## SERVICE BULLETIN INDEX

# **SERVICE BULLETIN No 1 Issue 1 5-10-01**

## **AMMENDED SEAT HARNESS ATTACHMENTS**

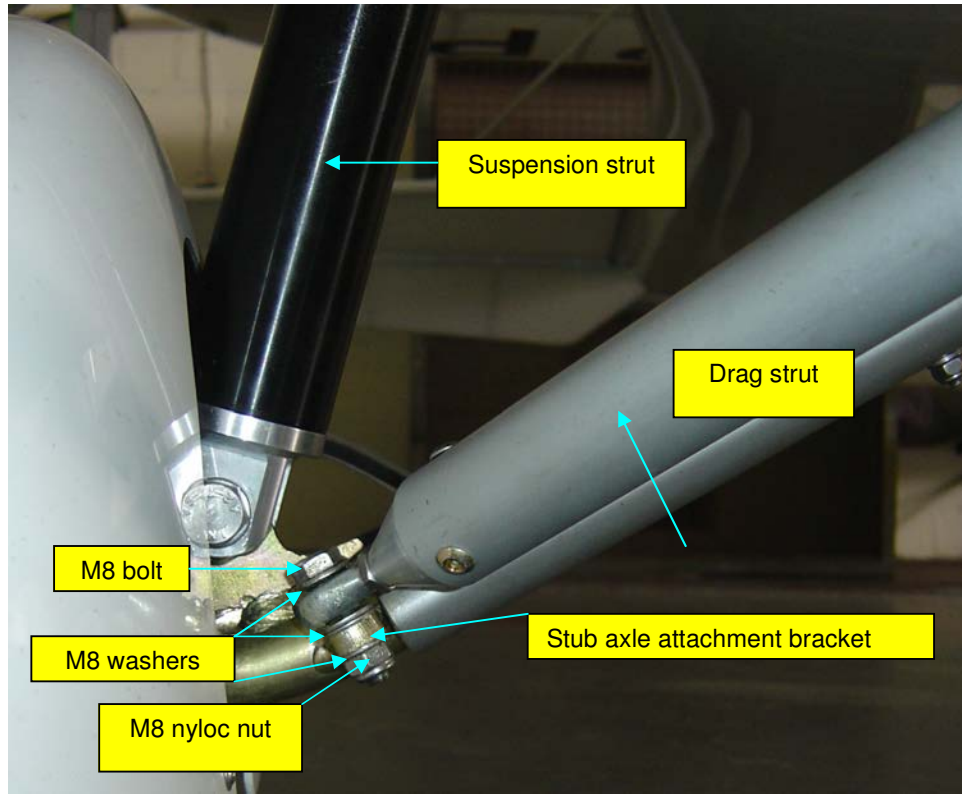
The bolt passes through a rose joint in the end of the drag link tube, then through an ear welded to the stub axle. Tension and compression loads on the strut result in bending loads being applied to the bolt. If such loads are applied to a threaded portion of the bolt, then bolt cracking, or fatigue failure initiated by the thread roots, are possible.

**Airworthiness Implications** – Bolt failure could result in undercarriage collapse in the event of a hard or fast landing on rough terrain.

- (a) Contact Aerosport Ltd for correct length bolts, additional washers and replacement nyloc nuts.
- (b) View diagram on next page which highlights affected bolt.
- (c) Apply the parking brake. Working on one axle at a time, remove the nyloc nut & washer from the M8 x 40mm bolt shown. Carefully remove the bolt taking care to note the quantity of any washers between the rose joint and stub axle attachment bracket. Re-assemble with the M8 x 50mm bolt, re-fitting the washers in their original position between the rose joint and stub axle attachment bracket. Fit additional washers under the nut, as required, to prevent the nut from becoming thread bound when tightened. Torque to 15Nm.
- (d) Repeat the procedure for the other axle.

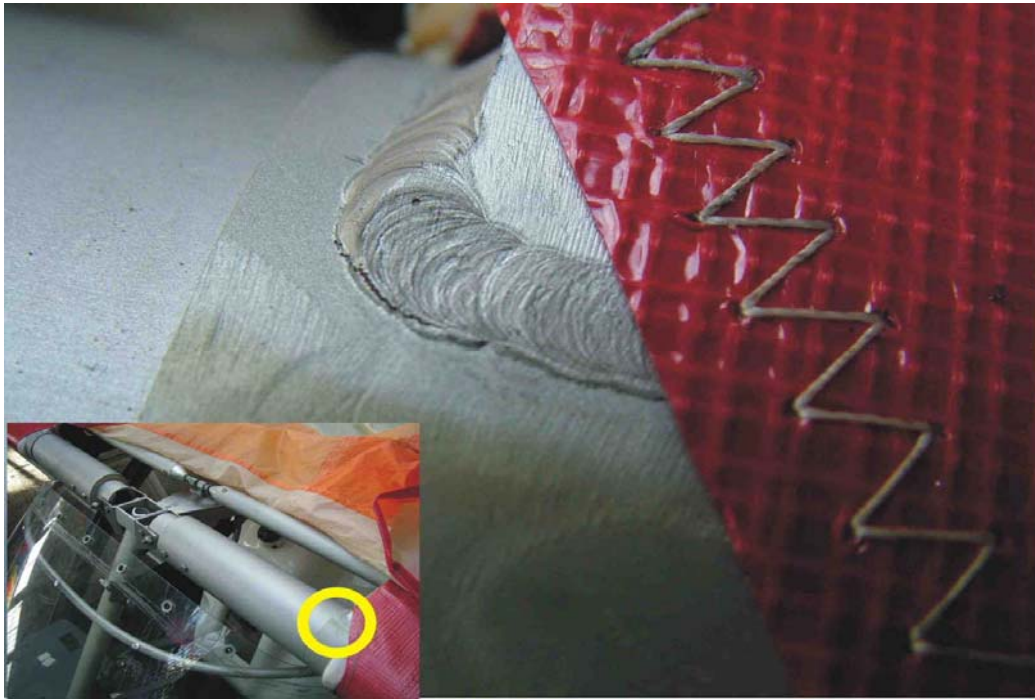
1. Remove the roof panel to expose the inboard area of the aluminium root rib where it is welded to the leading and trailing edges.
2. Carefully inspect the weld at this point for cracks. Where any uncertainty exists, use a dye penetrant for crack detection. Protect the screen and surrounding structure from dye spray.
3. If a crack exists, it will be necessary to remove the wing for disassembly. The part must be re-welded by a welder practiced and skilled in aluminium welding, or replaced by an Aerosport-supplied replacement part.
4. Enter the inspection and, if necessary the repair, in the airframe log book. This component is part of the airframe structure and the work must be inspected and signed off by a BMAA or PFA inspector as appropriate before flight.

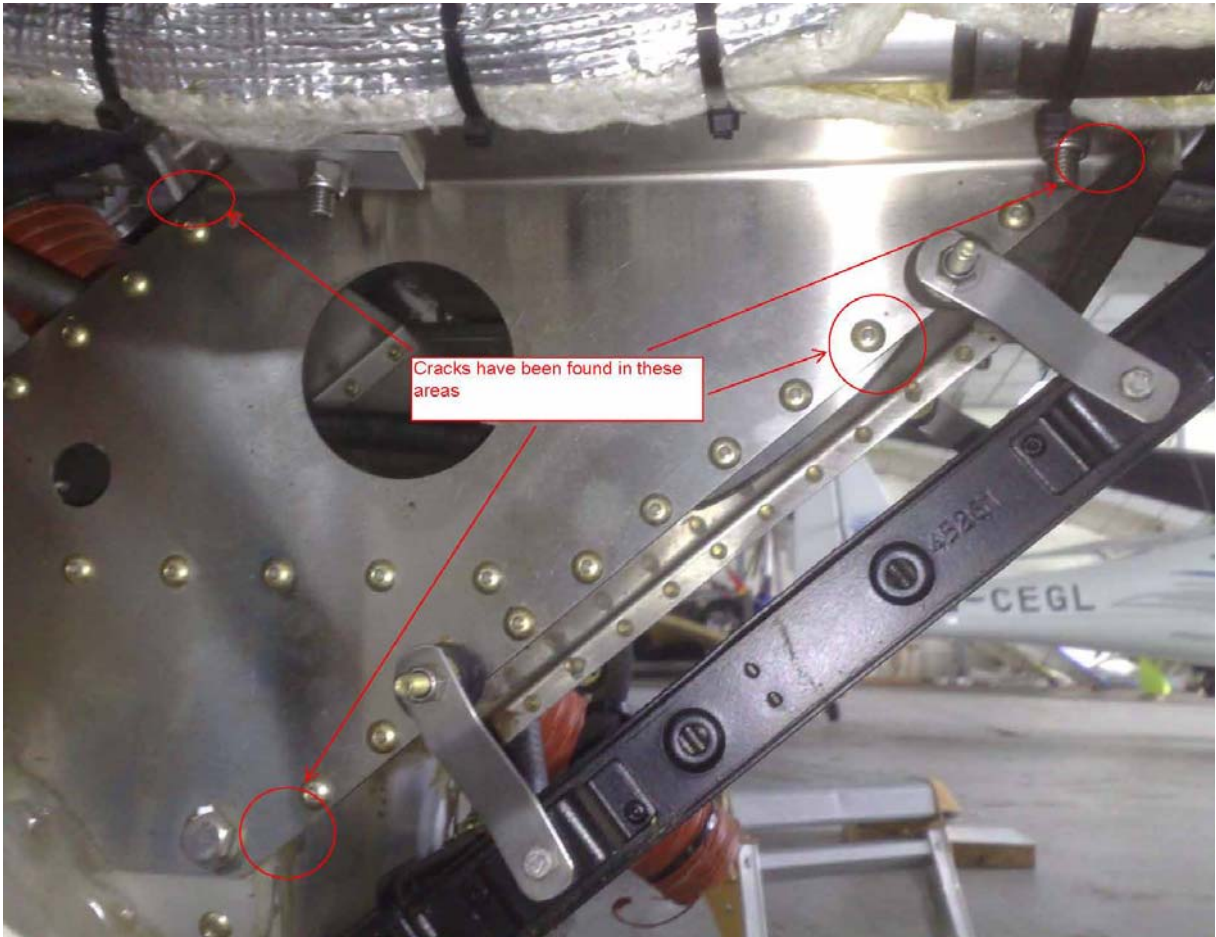
- When an aircraft reaches 500 hours flying time, carry out actions 1 to 4 below.
- For aircraft that have already reached 500 hours flying time, carry out actions 1 to 4 below before 30 June 2008
- Note that the maintenance manual will be amended to include this inspection in the 50 hour service interval.

1. Remove the top and bottom engine cowling so both sides of the engine mount can be seen.
2. Carefully inspect both sides of the mount for any cracks, especially in the areas highlighted in the photograph on page 2 with all the rivets near the edge of the side plates being checked. Pay particular attention to the lower part of the mount in the area depicted in the lowest red circle on the photograph. Where any uncertainty exists, use a dye penetrant for crack detection. Protect the surrounding structure from any dye spray.

**Picture 1**

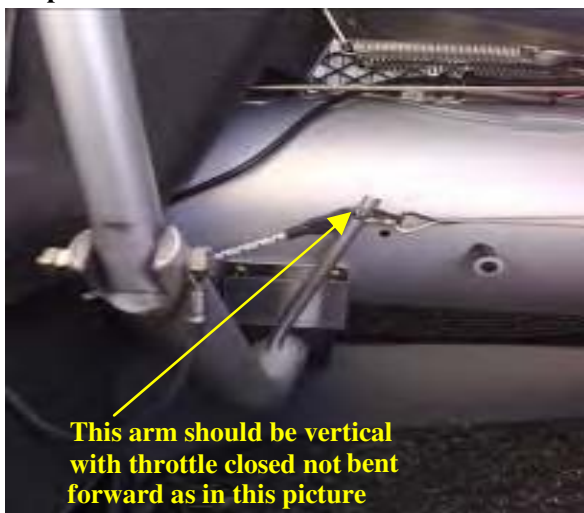
#### **Throttle Arm clevis pin catching on centre console side panel**

**See photos below.**

**Picture 2**

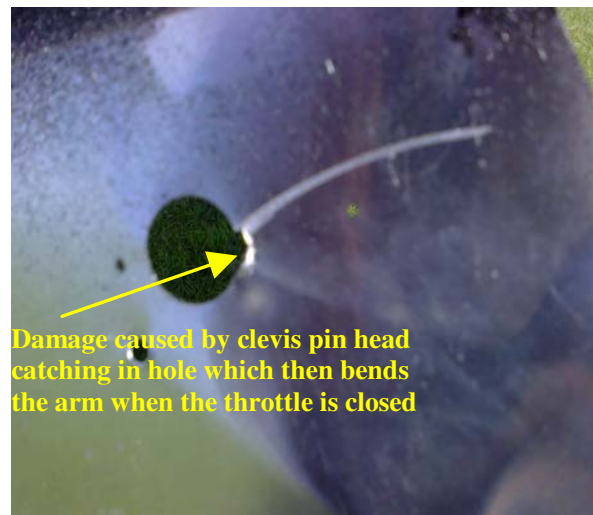
Preferably before the next flight or if not as soon as practical, carry out an intial inspection to see if the throttle arm has been touching the side panel - See picture 2 above. If there is any sign of contact then a longer screwed in spacer must be fitted so that an adequate clearance is produced between the panel and throttle arm. Even if no contact of the arm on the side panel is apparent, it is still recommended to carry out this modification.

1. Remove the right (passenger) side panel and the rearmost of the 2 plastic spacers from the main keel tube to the side panel and replace with a 30,0mm long threaded spacer. This involves fitting a M4 rivnut (see fig 1) into the same hole in main tube that the plastic spacer was removed from. The rivnut ideally needs to be fitted with a special rivnut tool or it can be fitted by temporarily screwing in a M4 bolt with a nut and greased washer attached into the rivnut and tightening the nut against the flange of the rivnut with the washer in between whilst holding the bolt to expand the rivnut to hold it secure into the main tube of the aircraft (see fig 2).
